UNITED STATES
DEPARTMENT OF THE INTERIOR
BUREAU OF LAND MANAGEMENTFORM APPROVED
OMB NO. 1004-0135
Expires: July 31, 2010**SUNDRY NOTICES AND REPORTS ON WELLS** *SCD Artesia*
*Do not use this form for proposals to drill or to re-enter an abandoned well. Use form 3160-3 (APD) for such proposals.***SUBMIT IN TRIPLICATE - Other instructions on reverse side.**

1. Type of Well <input checked="" type="checkbox"/> Oil Well <input type="checkbox"/> Gas Well <input type="checkbox"/> Other	8. Well Name and No. GISSLER B 52
2. Name of Operator BURNETT OIL CO., INC.	9. API Well No. 30-015-37241
3a. Address BURNETT PLAZA - SUITE 1500 801 CHERRY STREET FORT WORTH, TX 76102	10. Field and Pool, or Exploratory CEDAR LAKE GLORIETA YESO
3b. Phone No. (include area code) 817-392-5081 Ext. 6326102	11. County or Parish, and State EDDY COUNTY COUNTY, NM
4. Location of Well (Footage, Sec., T., R., M., or Survey Description) Sec 12 T17S R30E 2310FSL 1650FWL

DRILLING PLAN
Gissler B 52 Deepening

Gissler B 52
30-015-37241
Burnet Oil Co.
March 28, 2014
Conditions of Approval

BURNETT OIL COMPANY, INC.
 BLOWOUT PREVENTER &
 CHOKE MANIFOLD DIAGRAM
 2000 PSI WORKING PRESSURE

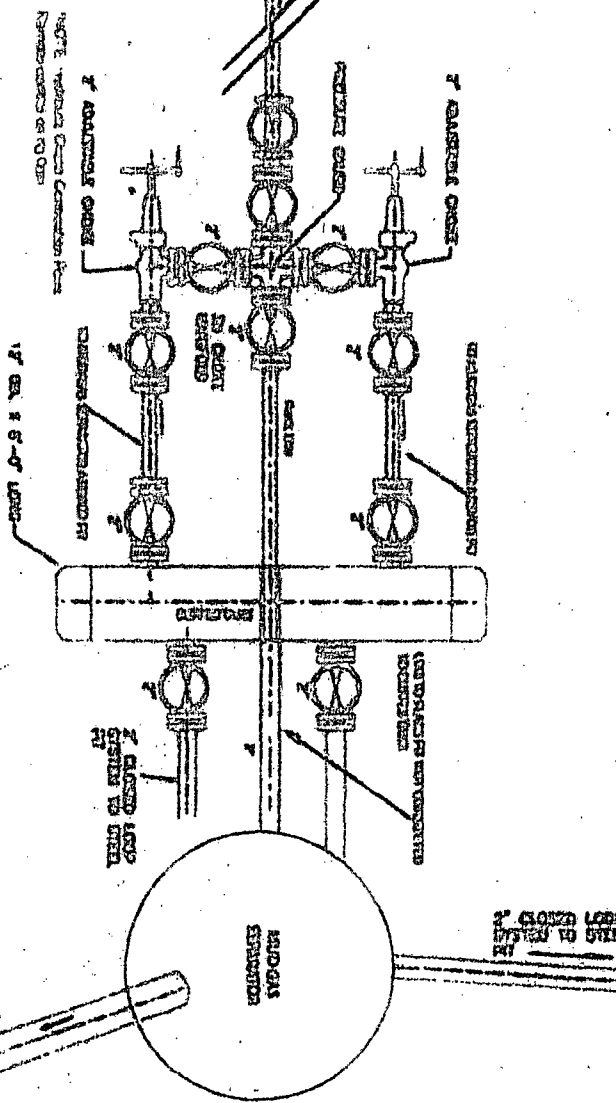
See COA The blowout prevention equipment (BOPE) shown in **Exhibit H** will consist of a 2000 PSI Hydril Unit (annular) with hydraulic closing equipment. The equipment will comply with Onshore Order #2 and will be tested to ~~50%~~ 70% of rated working pressure (RWP), and maintained for at least ten (10) minutes. The 7" drilling head will be installed on the surface casing and in use continuously until total depth is reached. An independent testing company will be used for the testing. Other accessory BOP equipment will include a Kelly cock, floor safety valve, choke lines and choke manifold having 2000 PSI WP rating.

5. BOP to be tested to **2000 psi** based on BHP expected. **In the case where the only BOP installed is an annular preventer, it shall be tested to a minimum of 2000 psi (which may require upgrading to 3M or 5M annular).**
